## DECISION OF THE PLANNING ADMINISTRATOR

**PARTITION CASE NO.:** PAR18-09

**SUMMARY:** A proposed partition to divide a lot along the northerly side of Belmont Street NE into three parcels. The existing single family residence would remain, while the accessory structure is planned to be removed.

**IN THE MATTER OF THE  
TENTATIVE APPROVAL OF  
PARTITION PLAT NO. 18-09;  
725 BELMONT STREET NE**

PARTITION TENTATIVE PLAN

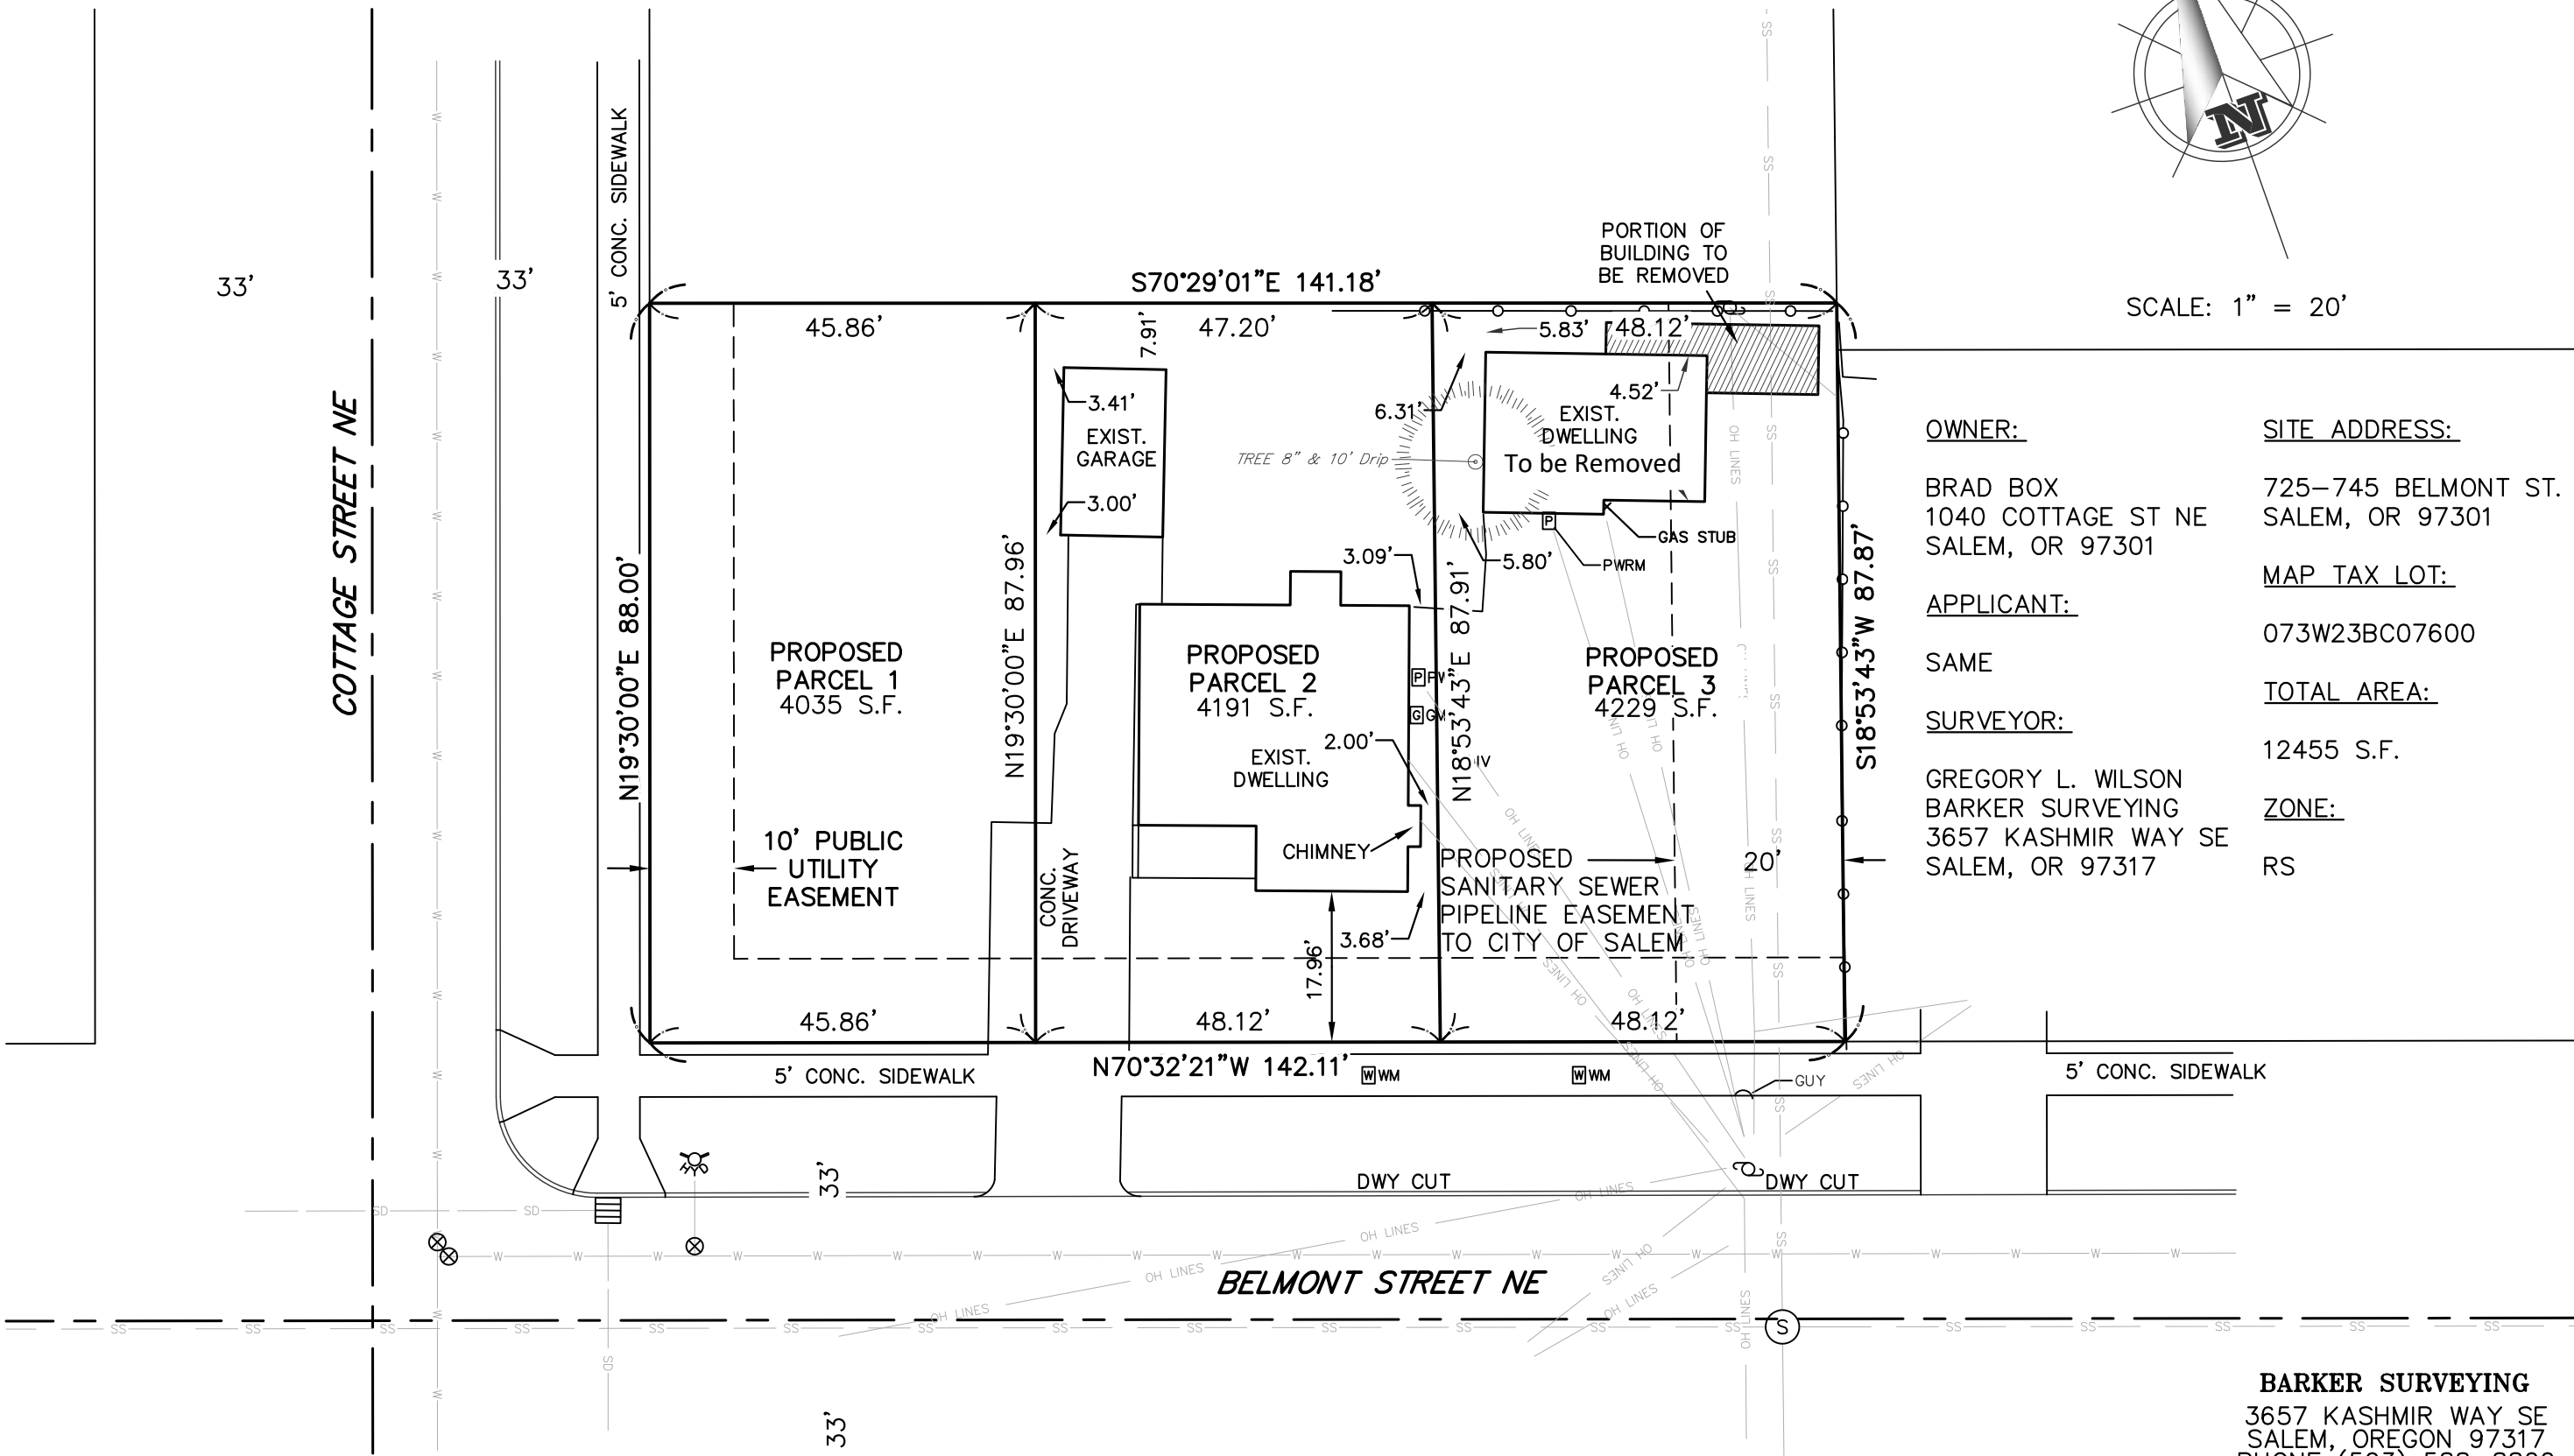
**Finding:** Water and sewer infrastructure is available along the perimeter of the site and appears to be adequate to serve the property as shown on the applicant's preliminary partition plan. As specified in the conditions of approval, private water, sewer, and storm services shall be constructed to serve each lot as a condition of plat approval. Construction of facilities in the right-of-way is required prior to final plat except as authorized in an improvement agreement per SRC 205.035(c)(6)(B). The sewer main located along the eastern portion of the subject property shall have a 20-foot utility pipeline easement centered over the existing pipeline pursuant to PWDS 1.8 - Easements.

**Findings**—Water and sewer infrastructure is available along the perimeter of the site and appears to be adequate to serve the property as shown on the applicant's preliminary partition plan. As specified in the conditions of approval, private water, sewer, and storm services shall be constructed to serve each lot as a condition of plat approval. Construction of facilities in the right-of-way is required prior to final plat except as authorized in an improvement agreement per SRC 205.035(c)(6)(B). The sewer main located along the eastern portion of the subject property shall have a 20-foot utility pipeline easement centered over the existing pipeline pursuant to PWDS 1.8 - Easements.

**Condition 2:** Obtain permits for installation of water services to serve Parcel 1 and Parcel 3.

**Condition 3:** Dedicate a 20-foot-wide City sanitary sewer easement measured from the eastern boundary of Parcel 3.

**Condition 4:** Provide private sewer easements where sewer services are located on a parcel other than the one being served.

**Condition 5:** Construct sewer services to the lot line for each parcel.
